**11-AFC-1**

**Re: Pio Pico Energy Center Project (11-AFC-1)  
Supplemental Responses to Data Requests Relating to Biological Resources**

**SUBJECT: 2010 – 2011 FAIRY SHRIMP SURVEY REPORT PIO PICO ENERGY CENTER PROJECT**

**FIGURE 3**  
**POOL/COMPLEX LOCATIONS**

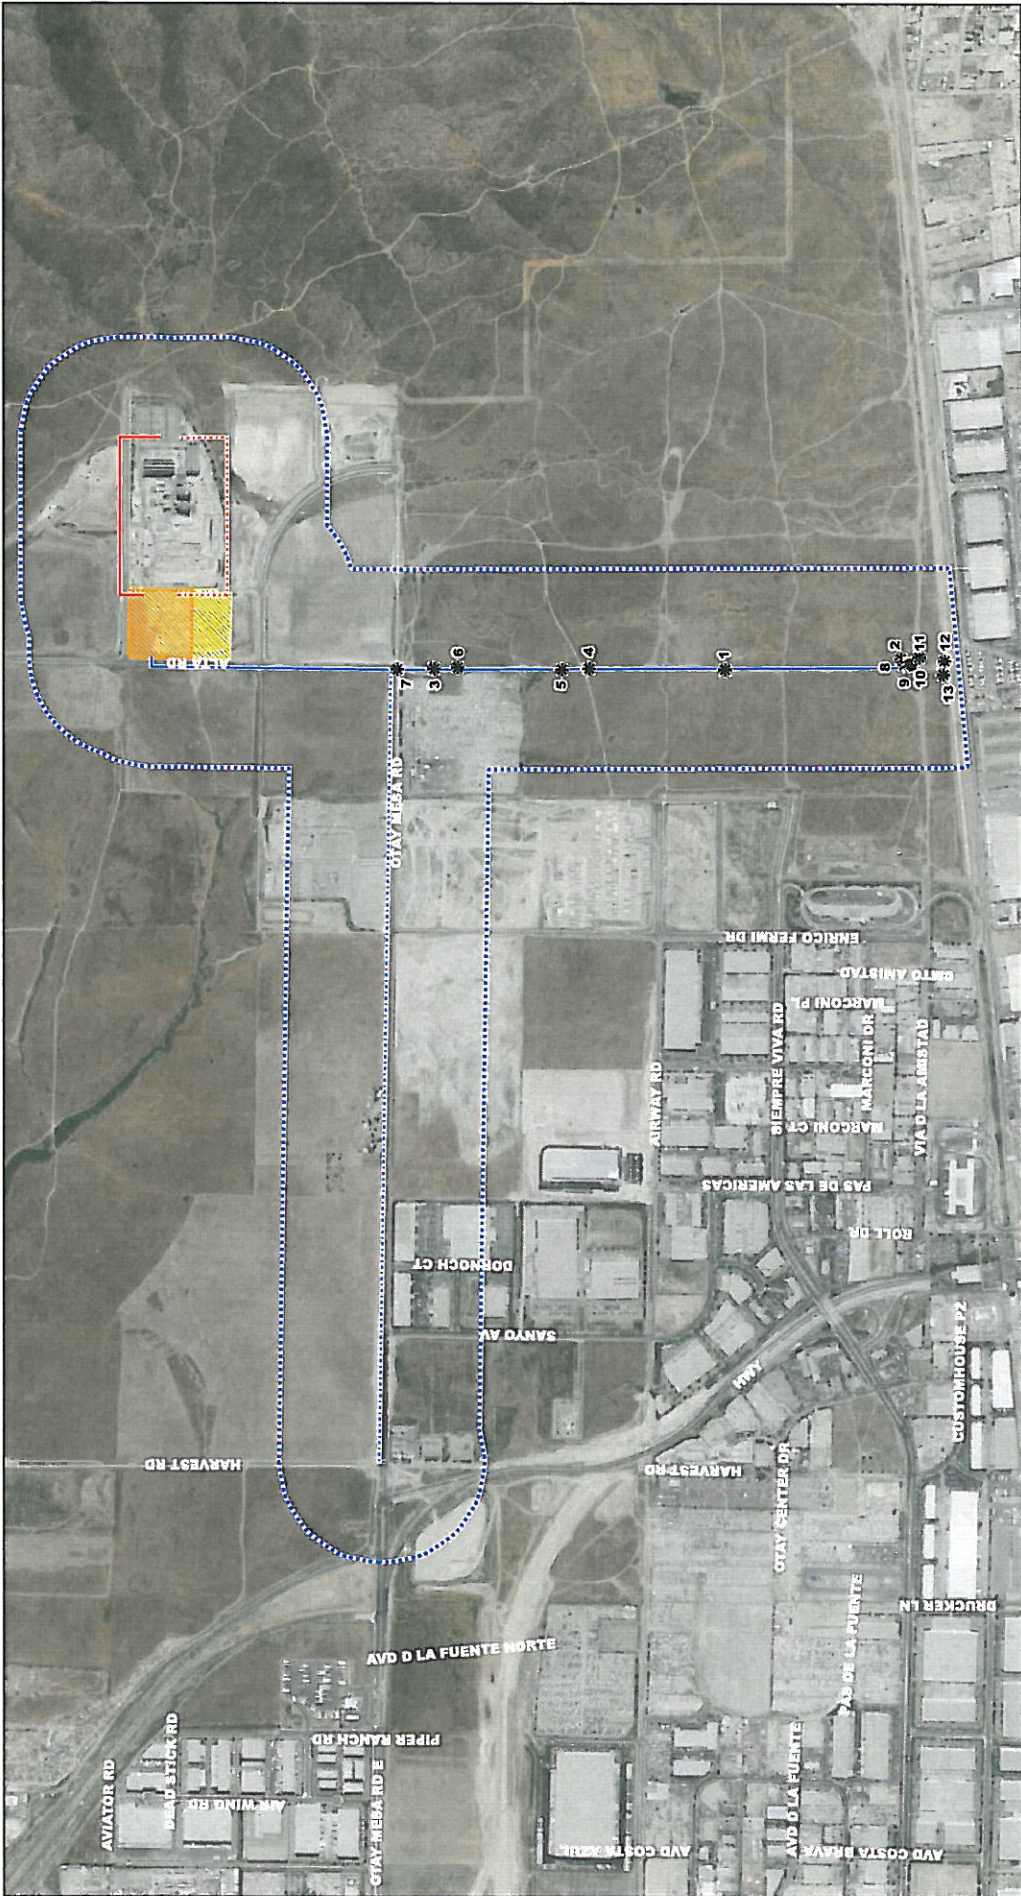
5. What is the status of the fairy shrimp protocol surveys and report?

5. What is the status of the fairy shrimp protocol surveys and report?  
**The surveys were conducted between December 14, 2010 and April 12, 2011. However, the report was not previously submitted as the filing of the AFC Refinement document on June 8, 2011 provided that the Modified Gas Line Route A specifically avoids avoid known populations of fairy shrimp within the region and avoids all potential habitat that may support vernal pools by not impacting the undeveloped areas of Alta Road. Notwithstanding the forgoing, a copy of the final report is attached.**

Thirteen basins and/or pool complexes were identified during the fairy shrimp surveys (Fig 3). Three pools, 2, 11 and 13 contained fairy shrimp species during the survey period. On February 1, 2011, Pool 2 contained one individual female *Branchinecta* species too small to ID to species. On February 2, 2011, Pool 11 contained approximately 10 *Branchinecta lindahli* individuals. On March 1, 2011, Pool 12 contained one individual female *Branchinecta* species too small to ID to species. No other fairy shrimp species were observed in any of the other basins/complexes surveyed. The results for each pool/complex are detailed in Table 3.
